Serial: RNP-RA/17-0068

H. B. ROBINSON STEAM ELECTRIC PLANT, UNIT NO. 2  
DOCKET NO. 50-261/RENEWED LICENSE NO. DPR-23

**RESPONSE TO NRC REQUEST FOR ADDITIONAL INFORMATION RELATED TO  
LICENSE AMENDMENT REQUEST REGARDING TECHNICAL SPECIFICATION  
SURVEILLANCE REQUIREMENT FREQUENCIES TO SUPPORT 24-MONTH FUEL CYCLES**

## APPENDIX A – CATEGORIZATION FLOW CHART

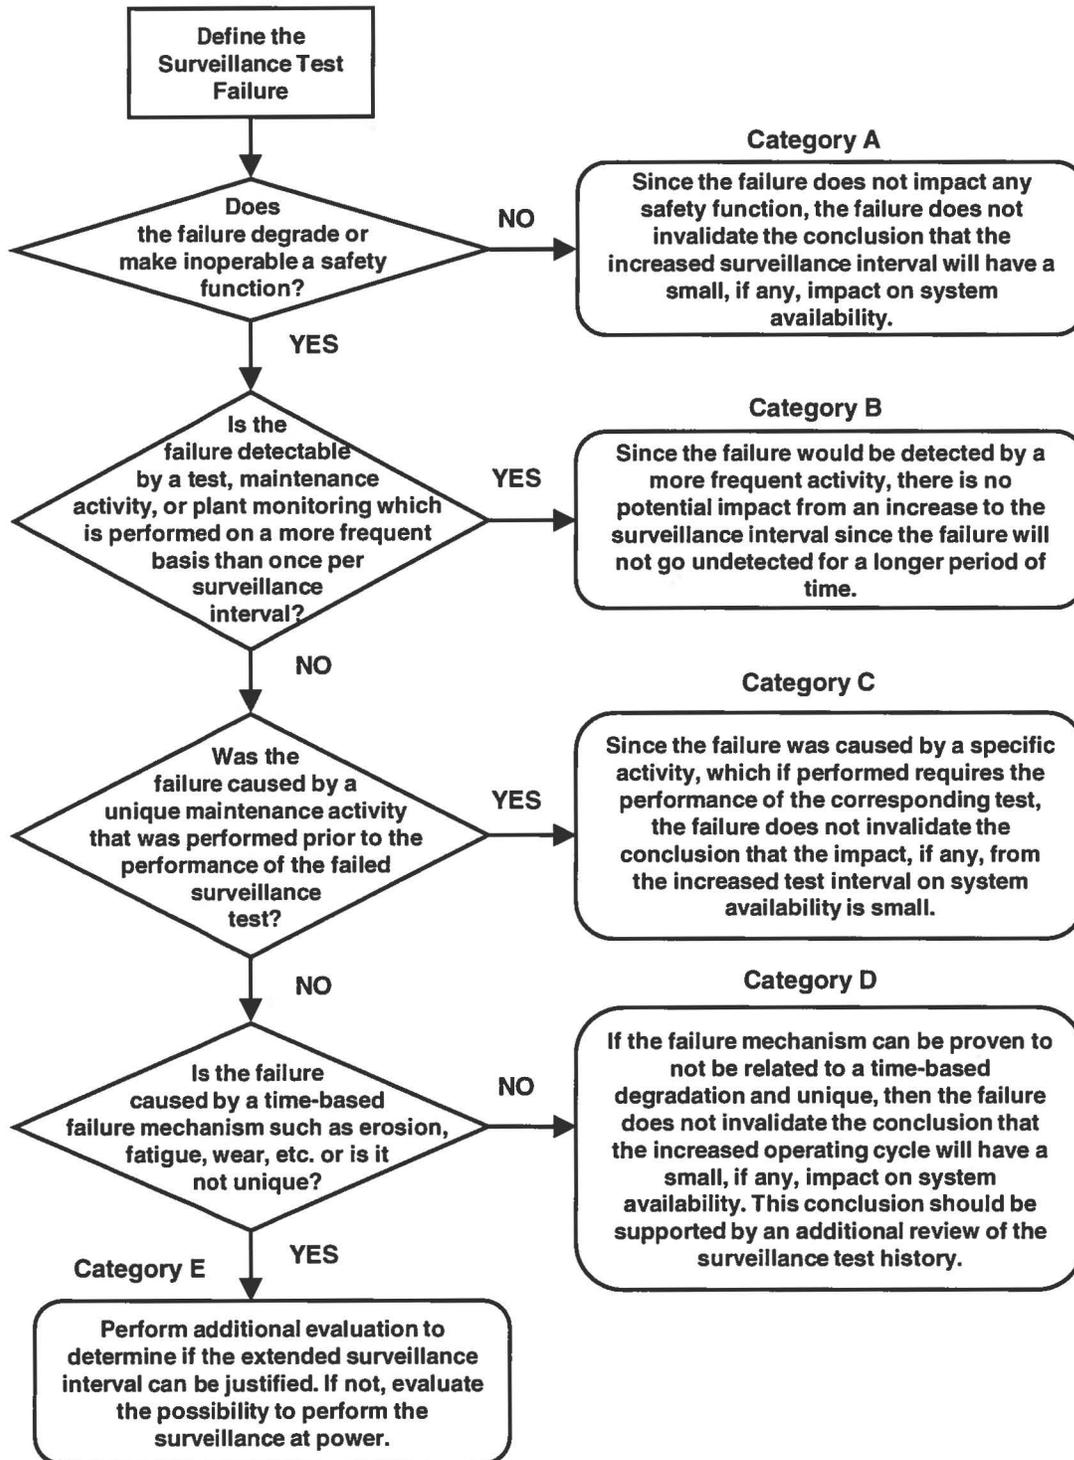
By letter dated April 3, 2017, as supplemented by letters dated April 3, 2017 and May 2, 2017, (ADAMS Accession Nos. ML17093A787, ML17093A796, and ML17122A223) Duke Energy Progress, LLC (the licensee) submitted a license amendment request (LAR) for H. B. Robinson Steam Electric Plant Unit No. 2 (Robinson). Attachment 8, "Non-Calibration Surveillance Failure Analysis" to the LAR lists the same three unique failure histories, as listed below, for a significant number of Surveillance Requirements (SRs):

- a. On 5/3/2007, CB-1 on Battery Charger A-1 failed to trip when power was removed from the charger.
- b. On 10/29/2008, input breaker CB1 on Battery Charger B-1 failed to trip on loss of alternating current voltage.
- c. On 6/20/2015, when placing the PZR HTR BACK-UP GROUP "A" switch to ON, the RTGB ON indication did not illuminate as expected.

The LAR states that the test procedure and preventive maintenance task implementing these SRs are very large and test a wide range of equipment. It is not clear how these failures are representative enough to demonstrate the lack of impact of the change in SR frequency for the wide range of and diversity of the SRs.

- (1.) Clarify the shared characteristics of these SRs that allow them to be treated as a group.
- (2.) Confirm that the same failure histories applies to all the SRs.

(3.) Alternatively, provide the appropriate failure histories for the SRs.

For the review of the acceptability of Surveillance failures, a study was performed to ensure that there is no evidence of repetitive surveillance test failures which would potentially result in a decrease in the system availability from the change to a 24-month surveillance interval. To demonstrate this, a comprehensive review of the surveillance test history for 18-month Technical Specification required surveillances was performed. The study included a minimum of five (5) surveillance performances, providing a minimum of seven (7) years of data which has been proven acceptable by the USNRC in previous license submittals for interval extension [Hatch Nuclear Plant (ML012700177), DC Cook Nuclear Plant (ML041200298), and Oconee Nuclear Station (ML101330499)]. In most cases, seven (7) surveillance test performances were used for conservatism (minimum 10 years). During the study period, all 18-month surveillance interval test failures were identified and dispositioned. To simplify the evaluations necessary for this study, surveillance test failures were classified into categories which have been generically justified, with the exception of Category D, Unique Failures. The classification technique is shown in the graphic shown as 'Appendix A – Categorization Flow Chart'. All the failures were evaluated per an Engineering Change. The failures in Categories A, B, and C can be demonstrated to not change the conclusion that the impact on system availability, if any, will be small as a result of the change to a 24-month surveillance test interval. The reasons for this conclusion are listed in the flowchart. Each Category D failure was evaluated individually and collectively to ensure that repetitive failures of similar components tested by different surveillance tests would be identified. These two evaluations (failure categorization and review of unique-Category D failures) did not identify any repetitive failures which could potentially invalidate the conclusion that the impact on system availability and safety would be small from the change to a 24-month surveillance test interval.

Engineering Evaluation EC 407942 evaluated all failures. Attached is an excerpt (subset) from Appendix C of Engineering Evaluation - EC 407942. This excerpt includes the portion that evaluated all failures found for OST-163 [Safety Injection Test and Emergency Diesel Generator Auto Start On Loss OF Power and Safety Injection (Refueling)] which is categorized and dispositioned for the 24 month surveillance interval (Partial Appendix C). This section was chosen as an example as it contained the three (3) unique failures listed in the RAI and is one of the largest 18-month surveillance tests at H. B. Robinson Nuclear Plant (RNP). This type of analysis and documentation was utilized for all surveillances potentially affected by extension of the surveillance interval to 24 months.

If a surveillance test was failed, the failure was conservatively applied to the failure history of all SRs which the test credited, even when only one section of the test was failed. Most failures were classified into categories that can be generically justified and shown not to change the conclusion that the impact on system availability, if any, would be small. The exception was "unique" failures. To ensure that repetitive failures of similar components tested by different surveillance tests would be identified, a separate evaluation was performed of all "unique" failures. This evaluation concluded the impact, if any, on system availability would be small. Since it was determined that there were no time based nor repetitive failures that would have a significant effect on system availability, it was not necessary to further analyze any smaller subset of the surveillance test.

In conclusion, a comprehensive review of surveillance test history was performed and all failures were systematically evaluated. This review did not identify any repetitive failures which could potentially invalidate the conclusion that the impact on system availability and safety would be small from the change to a 24-month surveillance test interval.
